STAFF REPORT
(Preliminary Plat)

CASE NUMBER: SUB 2002-105 -- FALCON-RIDGE^{FALLS} ADDITION

STAFF REPORT

CASE NUMBER: SUB 2002-105 -- FALCON FALLS ADDITION (formerly Falcon Ridge Addition)

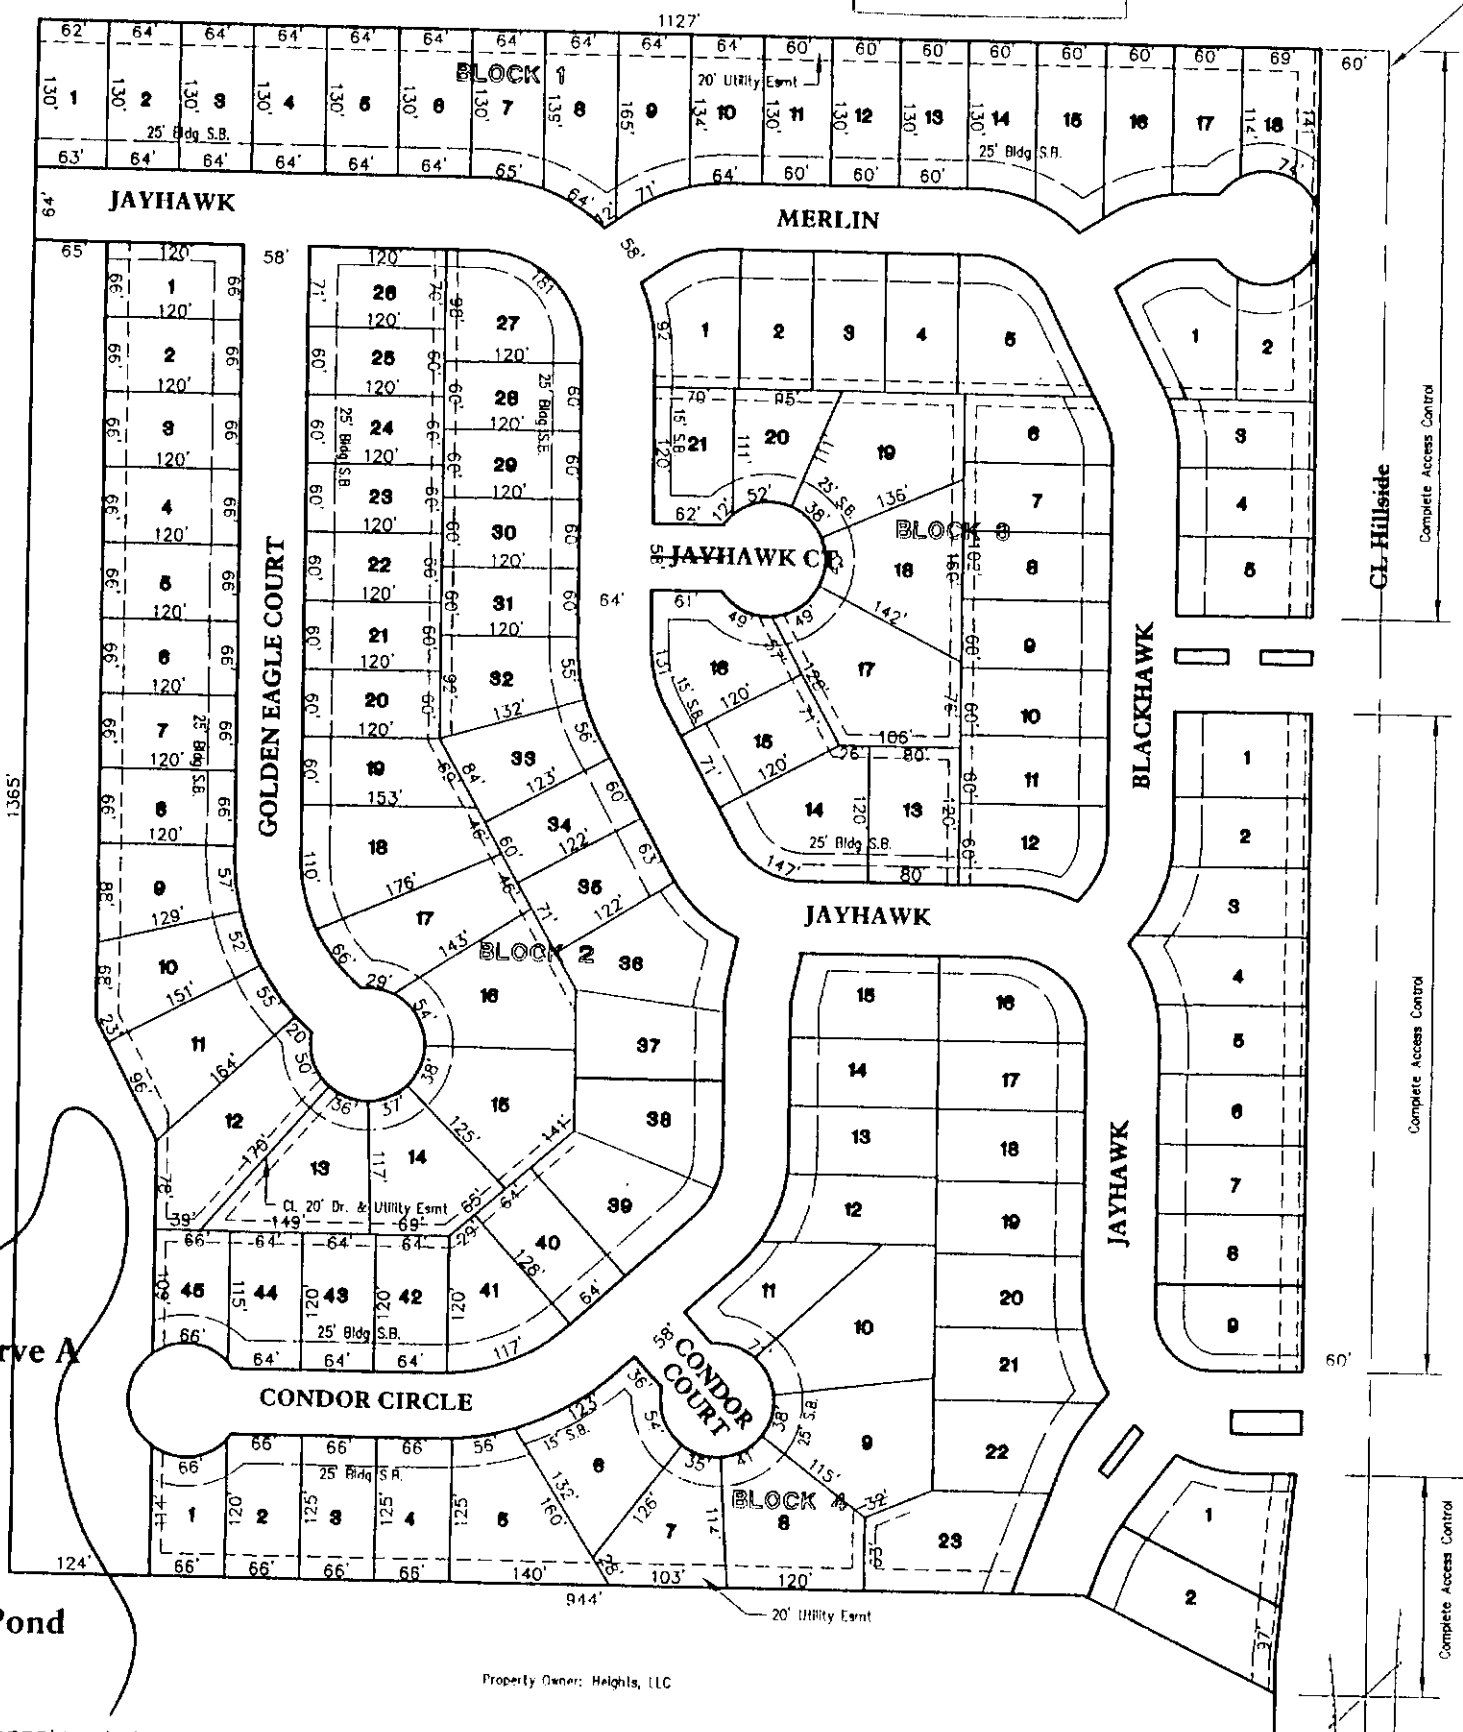
- D. County Engineering needs to comment on the need for any improvements to Hillside. Left turn lanes are needed on Hillside.
- E. The plat proposes complete access control along the plat's frontage to Hillside. In the plattor's text regarding Complete Access Control, Block 1 needs added and West needs changed to East.

- G. The paving guarantee shall include the installation of a temporary turnaround at the terminus of Falcon at the plat's south line. If off-site, the temporary turnaround shall be established by separate instrument. The plattor's text should indicate that the vacation of the temporary turnaround area will be effective upon the extension of the street southward.

- L. Dimensions and locations are needed for Reserves A, B and C.
- M. County Surveying has advised that the legal description does not close.
- N. The North line of the plat needs referenced in the legal description as being the "North line of the South 16.5 feet of the North half of the Northeast Quarter of Section 22".

- O. Dimensions need added or corrected on Lot 17, Block 1; Lots 8 and 10, Block 3; Lot 4, Block 5; Lot 4, Block 6; and Lots 1 and 2, Block 7.
- P. The applicant shall submit a covenant that provides for four (4) off-street parking spaces per dwelling unit on each lot which abuts a 58-foot street. The covenant shall inventory the affected lots by lot and block number and shall state that the covenant runs with the land and is binding on future owners and assigns.
